RE: Response to Public Notice Comments
Permit No. PSD-TX-1288-GHG
La Paloma Energy Center, LLC
Harlingen, Cameron County, Texas

This is a response to some of the issues raised in the Sierra Club letter dated April 19, 2013 regarding Permit No. PSD-TX-1288-GHG for La Paloma Energy Center, LLC:

Figure 24: Heat Rate Degradation – Combined Cycle

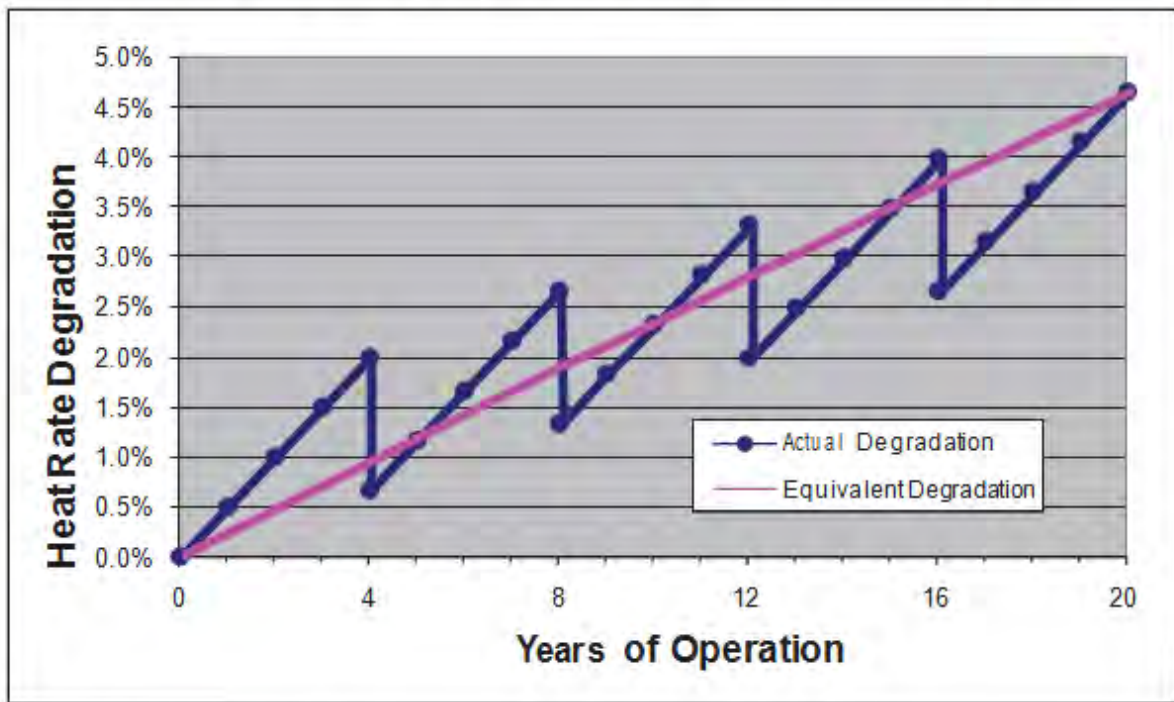
2. In comment 2, the Sierra Club questions the compliance margin adjustments to the Best Available Control Technology (BACT) limits for design variation, performance losses, and degradation.

The performance margin for equipment degradation relates to the combustion turbine and steam turbine generators. Refer to the attached California Energy Commission publication CEC-200-2010-002; Cost of Generation Model Users Guide Version 2 dated March of 2010. Figure 24 in this publication (copy attached) provides a clear illustration of the performance degradation of combustion turbines through the life of the unit. This "sawtooth curve" indicates the potential degradation and performance recovery following major service. This publication also references GE Technical Bulletin GER-3567H; GE Gas Turbine Performance Characteristics (also attached). This bulletin states, "Typically, performance degradation during the first 24,000 hours (the normally recommended interval for the hot gas path inspection) is 2% to 6%." The sawtooth curve in the CEC publication uses the view that the degradation will be limited to 2% between inspections and that 75% of that performance will be recovered resulting in a 20 year degradation of 4.5%. Considering the atmospheric conditions, high heat, humidity, and semi-corrosive salt air at the project location, La Paloma has taken a slightly more conservative view of this degradation. La Paloma projects the potential degradation to be 3% between inspections (considerably less than the potential 6%) and assuming the same 75% performance recovery; calculating a 20 year degradation of 6.0%.
